Response to editor comments:

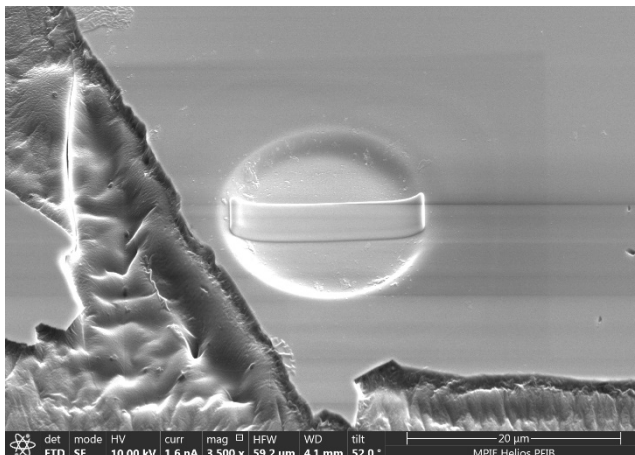
Line 238-239: 'This reconfirms that radiation damage lowers the Pb retention performance of zircon.' This statement seems to imply that radiation damage leads to discordance, for which I see no direct evidence. It is a pre-condition necessary for low temperature Pb loss following alteration. It might have been worthwhile to search for any evidence of alteration using high resolution BSE images of the SHRIMP target areas associated with discordant data.

Yes, but BSE wouldn't have told us what the alteration is; it would only tell us about a change in density or mean atomic number. Our Raman mapping gave us more information. Also, we have a wide variety of additional images which has not been included for space, including the SEM images related to preparing the APT sample. For example, this is what our CA OG1 zircon (spot C-13.1) looks like at 3500x with the protective metal foil added:
